[Docket No. 2001-SW-40-AD; Amendment 39-13022; AD 2002-13-05 R1]

Airworthiness Directives; MD Helicopters, Inc. Model 369D, 369E, 369F, and 369FF Helicopters

ACTION: Final rule.

Figure 1 - Inspection Location

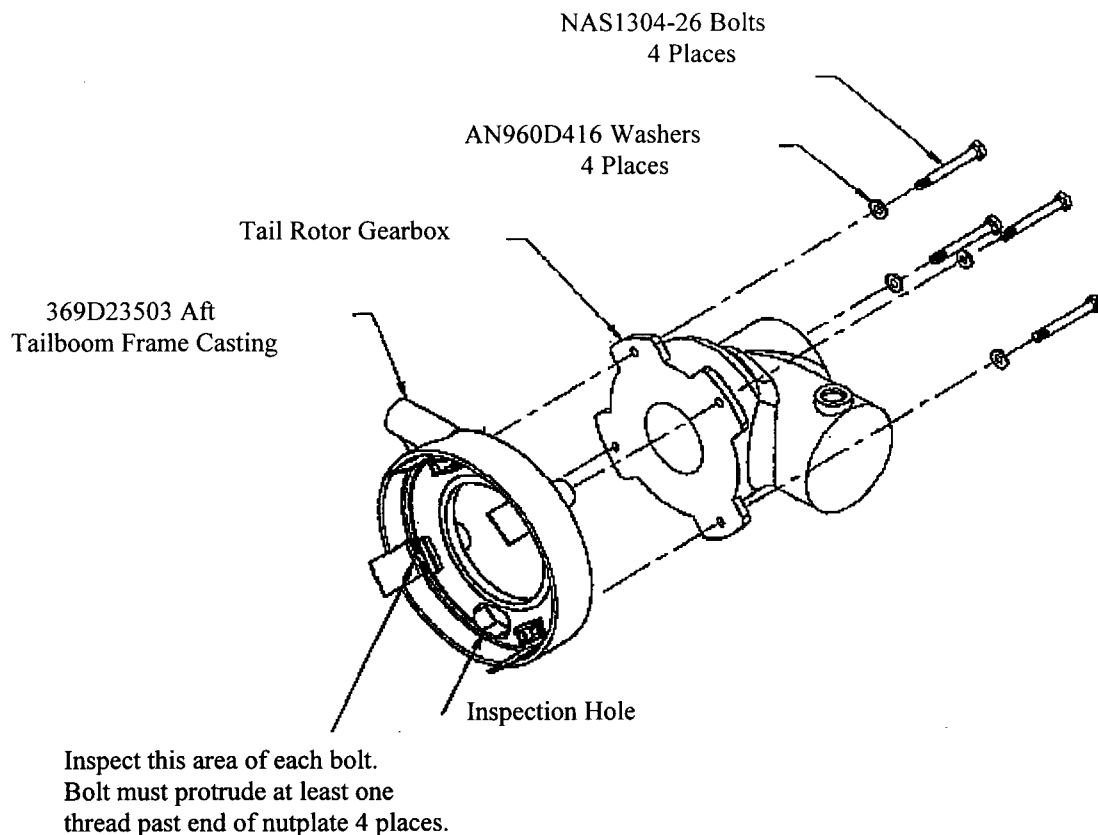
concern was valid. We are now reducing the applicability of AD 2002-13-05 to include only certain tailboom S/N's and parts that are modified in accordance with either STC SH5055NM or SH4801NM. We are also correcting the P/N for the washer to P/N AN960D416 in Figure 1 of this AD and clarifying that a slippage mark needs to be reapplied to each bolt regardless of the outcome of the required torque test.

further flight, replace the bolt with bolt, P/N NAS1304–26.
(iii) Torque the bolt to 100–110 in-lbs and apply a slippage mark.
(2) Remove the tailboom control rod and determine the number of bolt threads protruding from each nutplate on the internal surface of the aft tailboom frame casting, P/N 369D23503, as shown in Figure 1 of this AD. At least one thread must protrude. If more than four threads protrude, add an additional washer, P/N AN960D416, under the bolt head. Torque the bolt to 100–110 in-lbs, and reapply a slippage mark. *See Figure 1:*

(b) Between 2 and 10 hours TIS after accomplishing the requirements of paragraph (a) of this AD, inspect the torque on each bolt by applying 100 in-lbs. If any bolt movement occurs, retorque the bolt to 100–110 in-lbs. Reapply a slippage mark to the bolt regardless of the outcome of the torque test. Reinspect the torque between 2 and 10 hours TIS thereafter until no bolt movement occurs.
